REQUEST FOR INFORMATION **DATE:** April 13, 2016 **NO.:** RFI-034

Project Name: Webster University Interdisciplinary Science Building Project No.: 15051

Subject: Existing irrigation lines at ISB project

L170

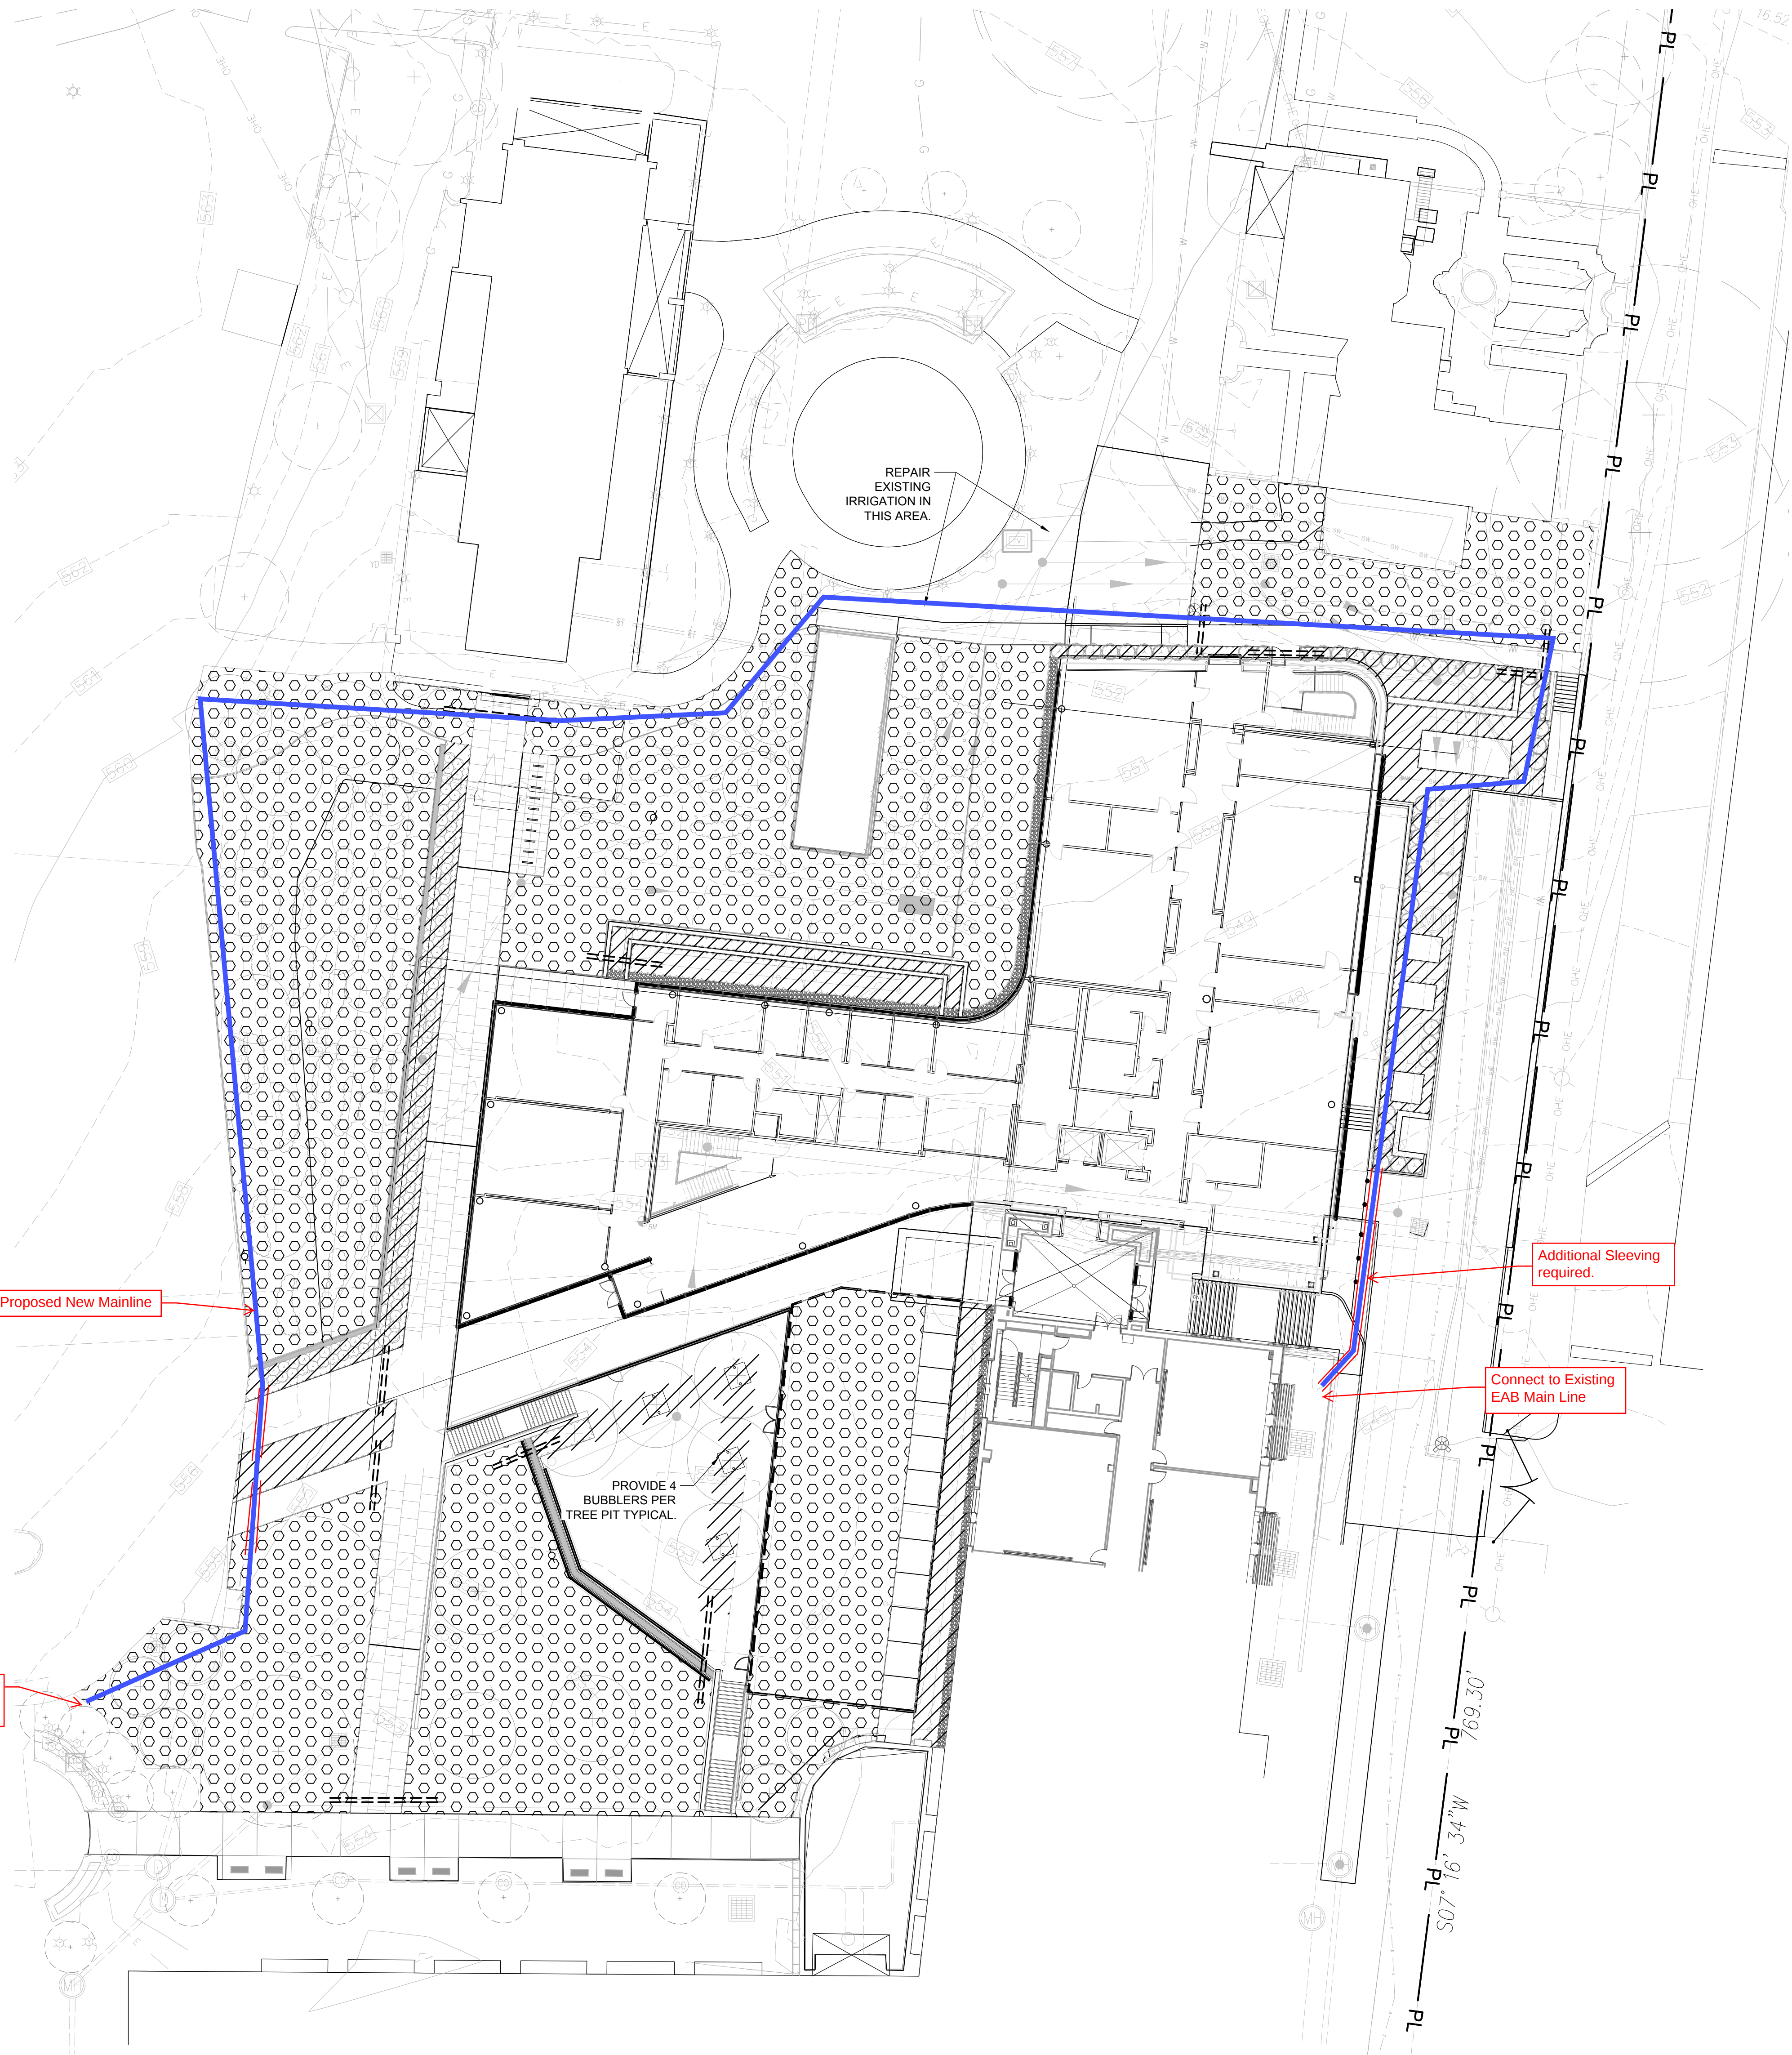
There are existing irrigation lines running thru the ISB project limits that will need to be relocated to construct the building. See attached plan markups. These lines feed out of the East side of the EAB. Should these existing lines be relocated back so the existing irrigation system feeds in a similar manner? Or should the new irrigation system incorporate new zones to accommodate the adjacent existing areas? Please advise.

Since area to be irrigated with the ISB project is no greater than what is currently being irrigated by the EAB system, SWT recommends designing the new ISB irrigation as a modification to the existing EAB irrigation system. Making adjustment to existing zones and utilizing the existing EAB controller and main line connection. See attachment for suggested routing for mainline.
